Day Theater DOS Study - Portland, Oregon
design planning meeting #3

DAY THEATER

PDC - D.O.S. STUDY

DAY THEATER RENNOVATION - FIRE EXIT STUDY

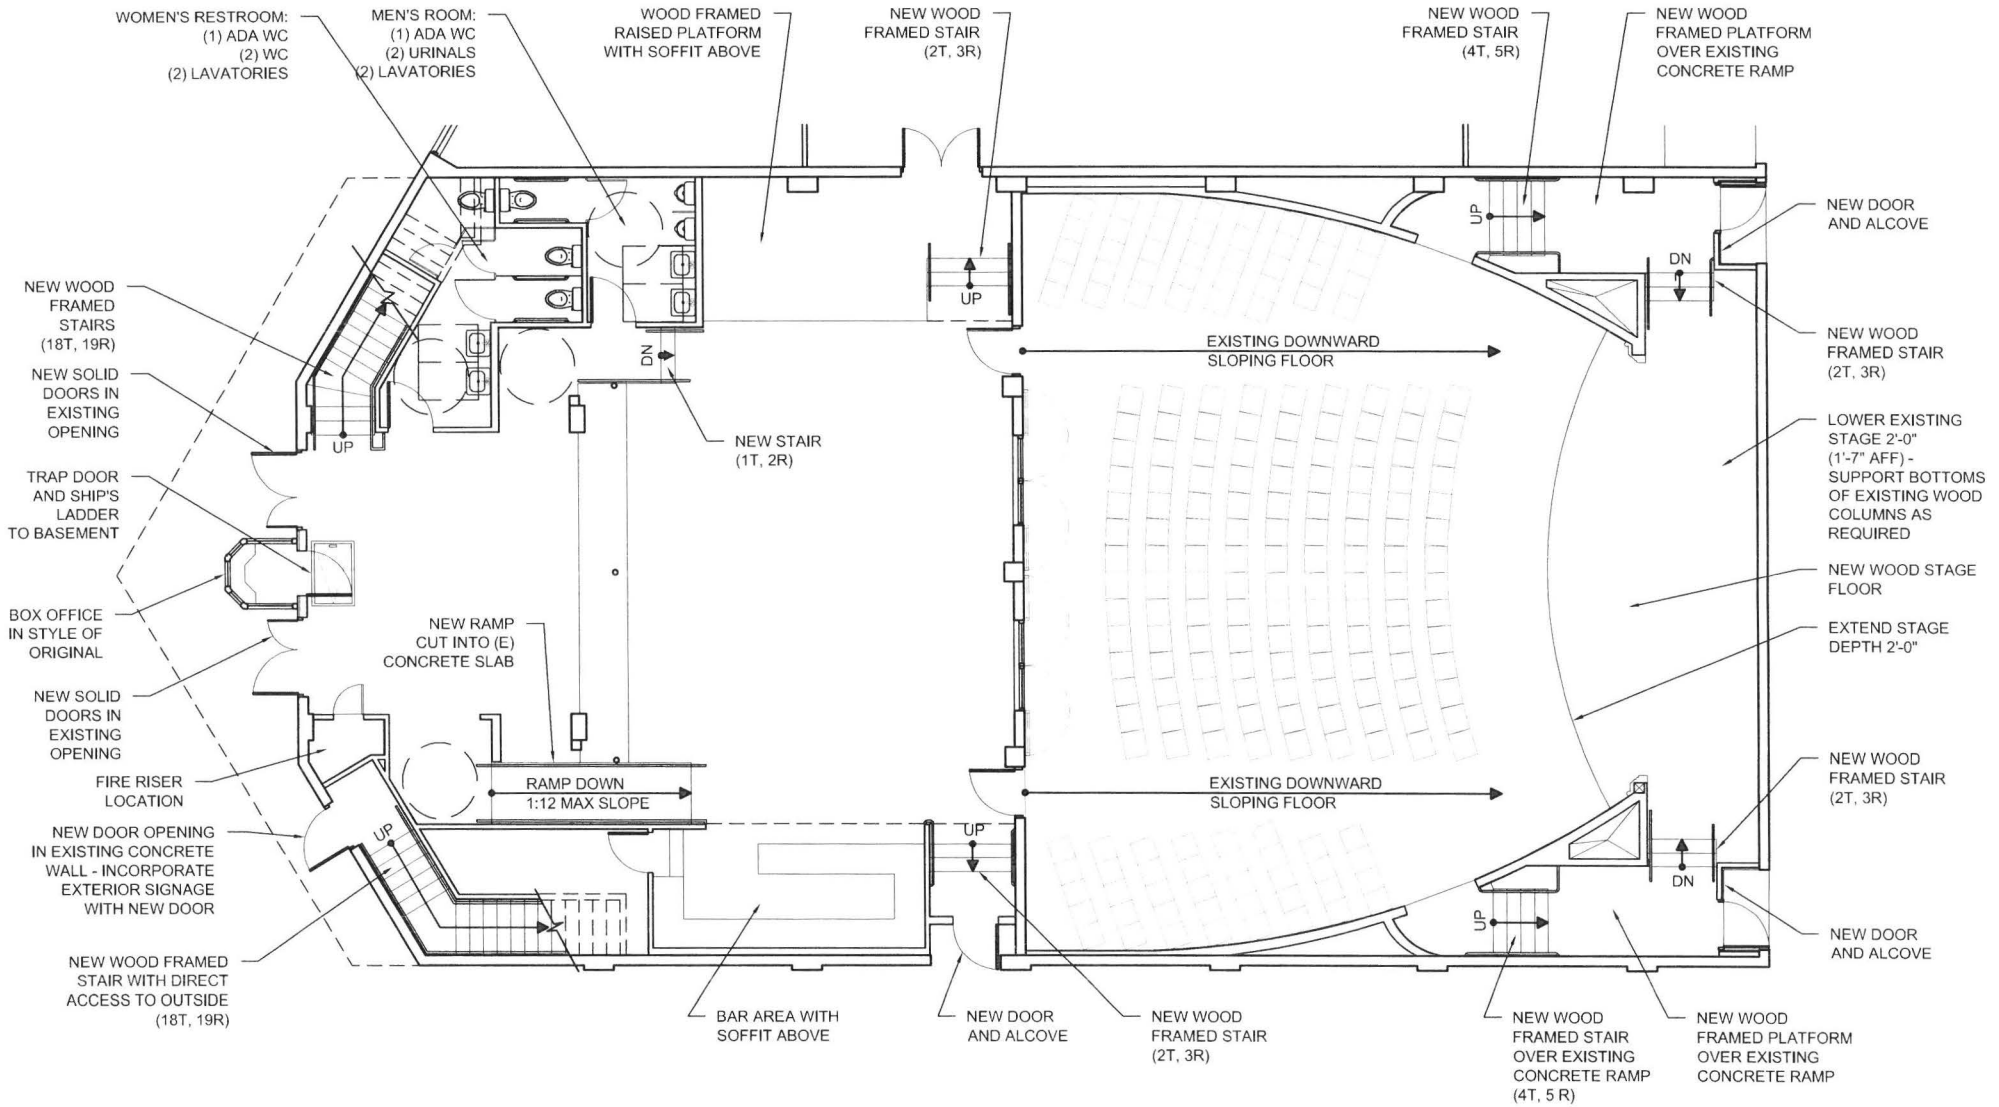
I tried faxing this to you but it wouldn't go through. I put the restrooms you had drawn up into CAD and added all of the ADA required clearances. You'll notice too that I am suggesting the option of cutting a ramp into the existing concrete slab in order to get a straight ramp rather than one with multiple turns. This also gets the ramp out of the lounge space and frees up views to the stage. The circulation still isn't a straight shot, but I feel like it's a step in the right direction. Let me know what you think - I hope you're feeling better!

Date | JUNE 8, 2009
To | TRACY ORVIS, DILORETO ARCHITECTS
Fax # | (503) 736-9975
From | BILL HAWKINS
Re | LAVATORY REVISIONS
Project # | DMY THEATER - REMODEL

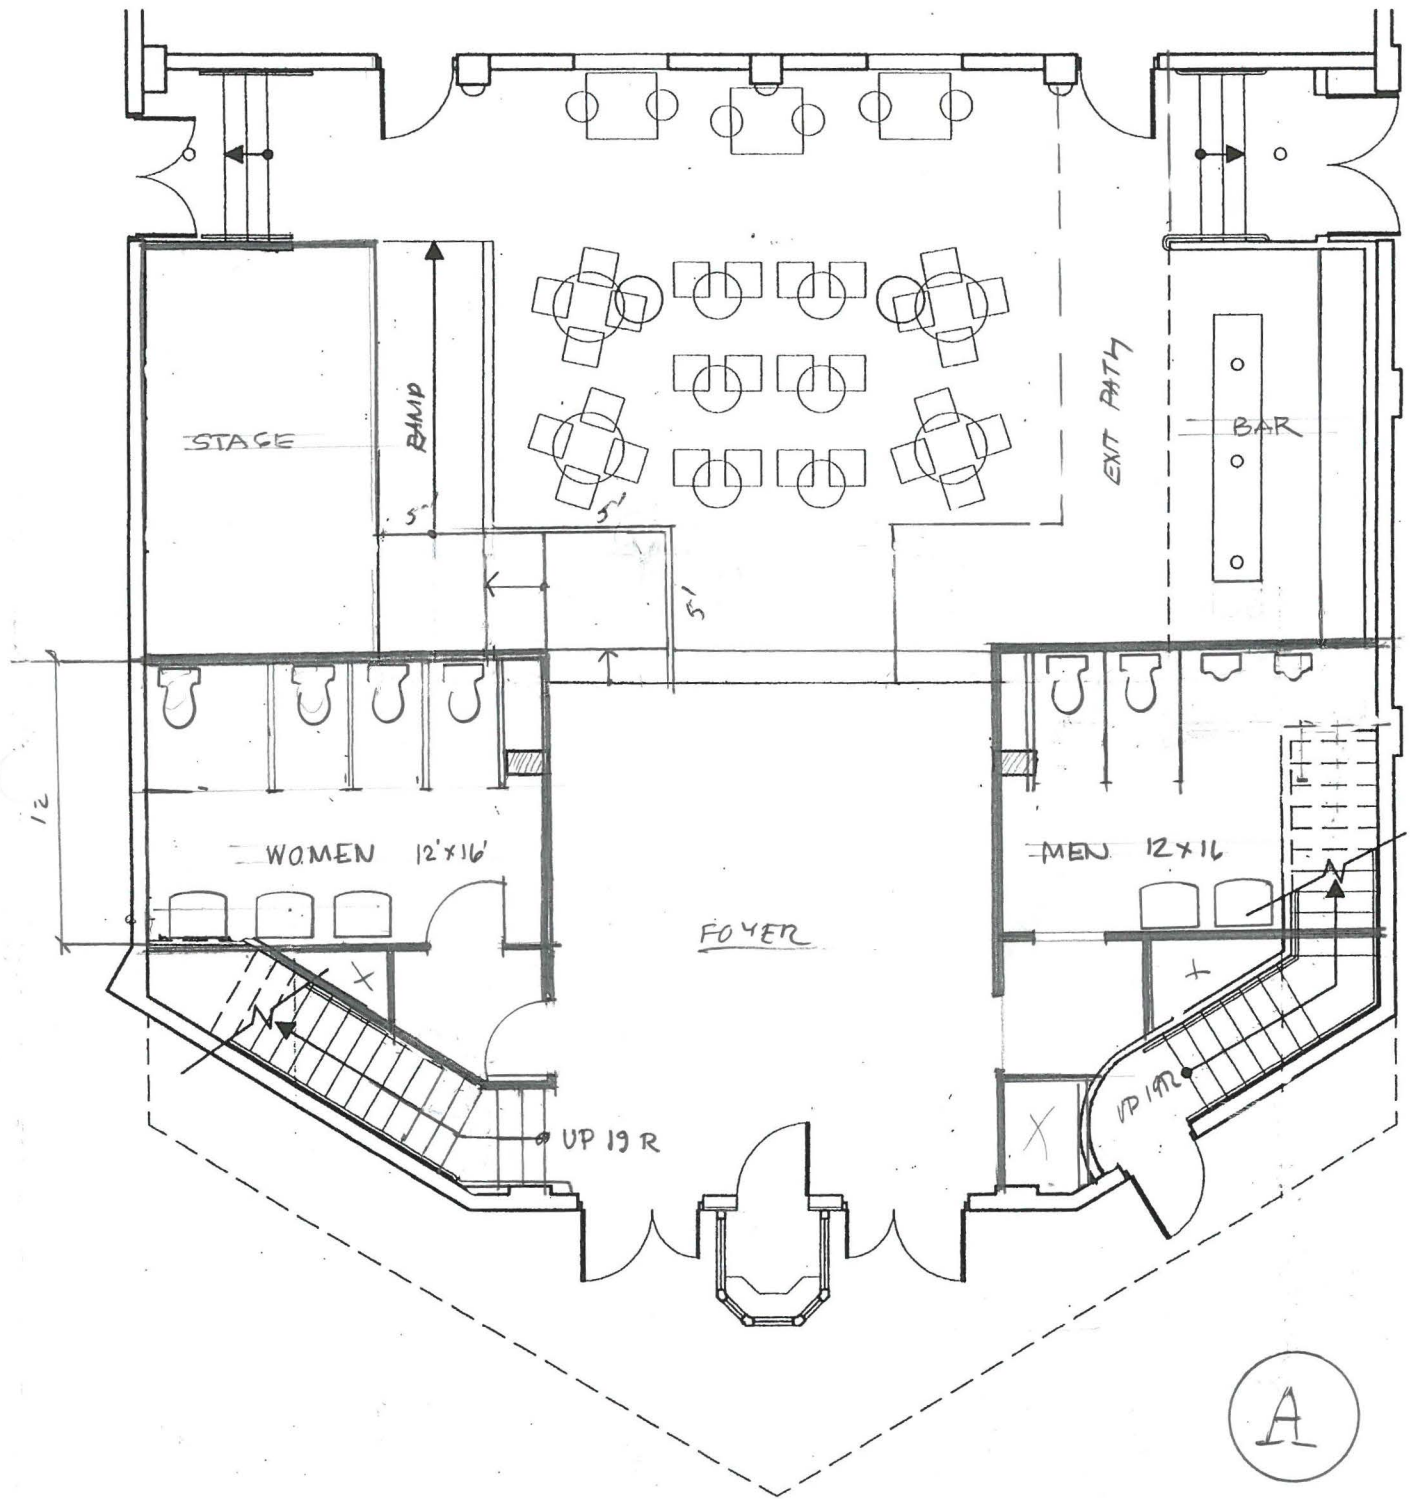
SOMETHING FOR YOU & CHRIS TO PONDER —

(A) - AS CLOSE TO TIM'S REQUEST AS POSSIBLE

(B) - TIM'S IDEA W/ SAME NO OF FIXTURE
AS WE WERE USING, — STARS WORK, BUT
ARE 'COSY' IN PLACES.

Date JUNE 2, 2009
To TRACY ORUIS
Fax # (503) 736-9975, CHRIS DILORETO, ARCHITECTS
From BILL HAWKINS
Re SUGGESTIONS FOR PLAN
Project # DAY THEATER

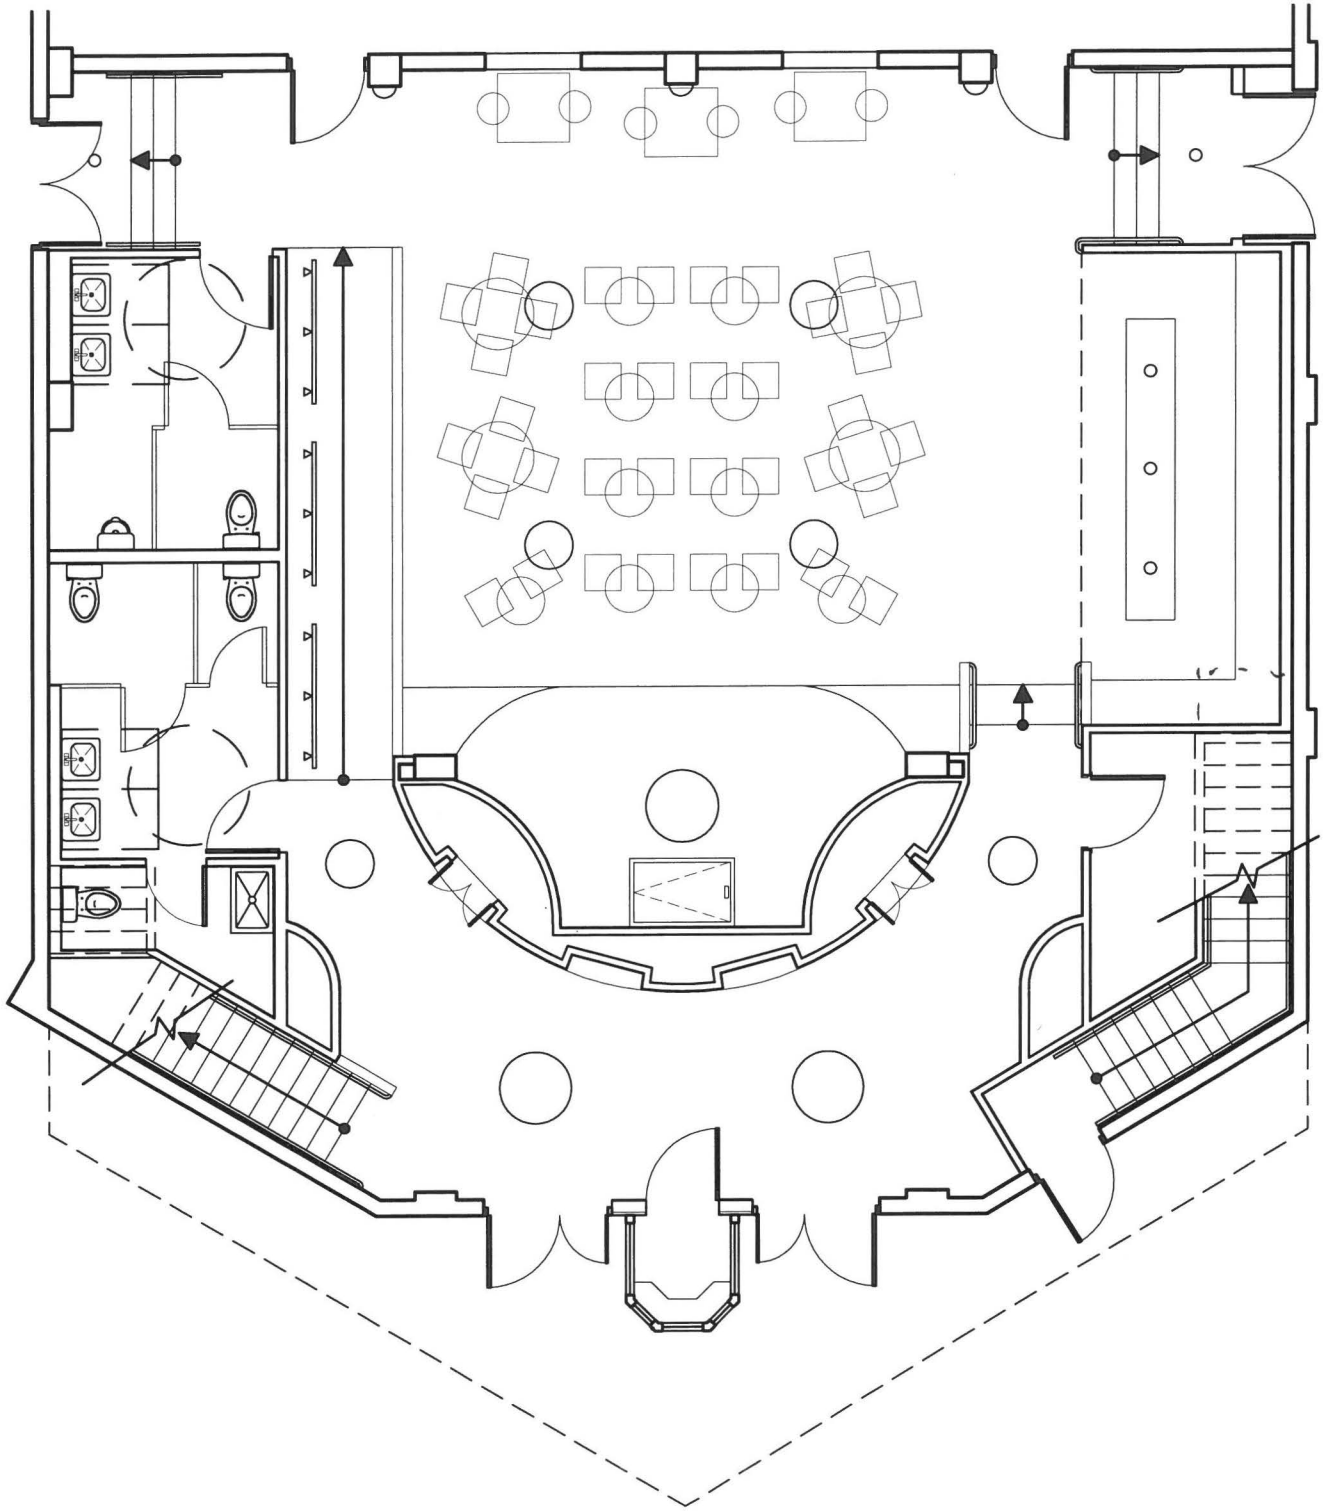
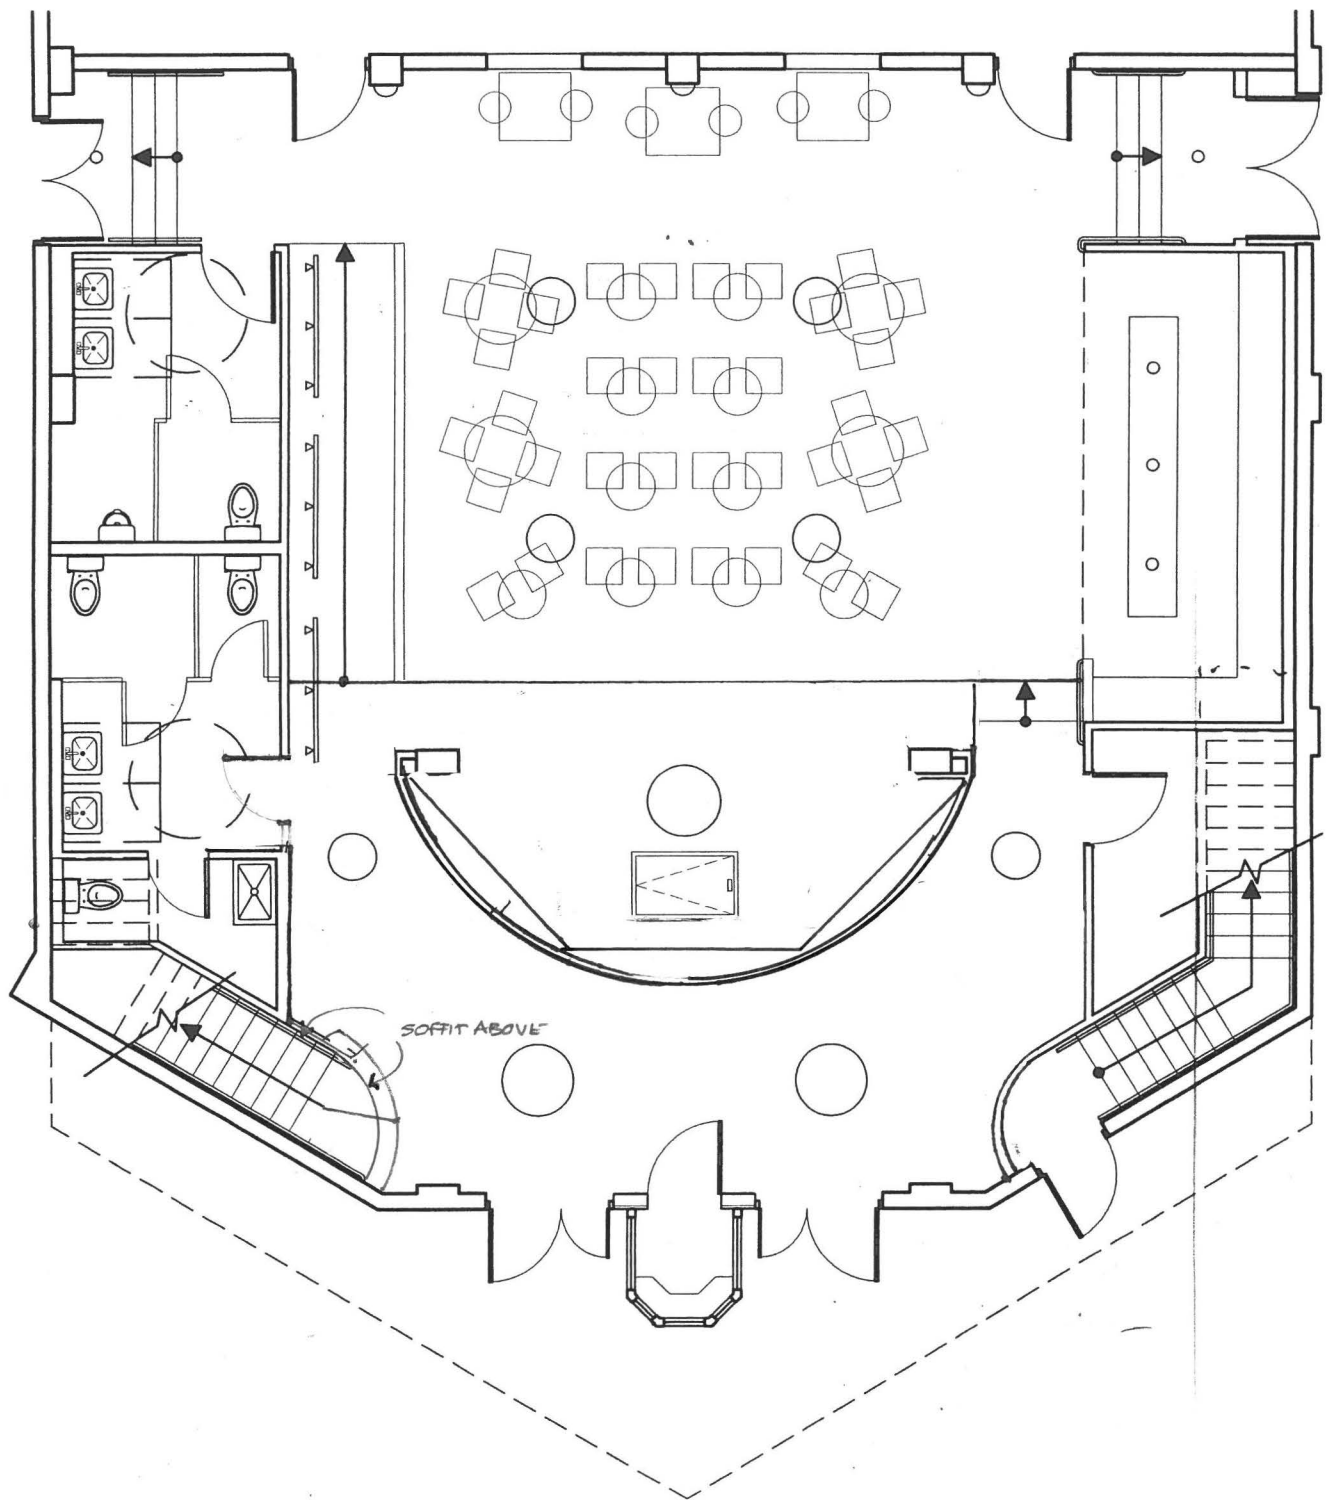
2 SKETCH CHANGES & THOUGHTS —

- THE ROUNDED STAGE BACK IS PERFECT. BUT ON THE ACOUSTICAL SIDE I THINK AN ANGLED WALL IS CALLED FOR. IS THERE ROOM FOR A SMALL LADDER/STAIR TO BASEMENT AREA?
- I'VE SUGGESTED TAKING OUT ² EXIST. CURVED WALL[^] & MAKING NEW ONES — FOR SIMPLICITY & CLARITY, THESE, AGAINST THE CURVED STAGE WALL SHOULD BE ENOUGH "MODERN" FOR A SMALL AREA. KEEP YOUR DECORATION ON THIS WALL (& THE OTHERS?). THEY ARE GREAT!!
- ^{MY} OLD-FASHIONED WAY ON SECOND PAGE — DIRECT (POSSIBLE) VIEWS OF URINAL & W.C. ARE NOT GOOD W/ FOOD, ONE MAXIM OF MY SPENDY EDUCATION[^] & MONS. ^{JEANNE PAUL CARLIAN}
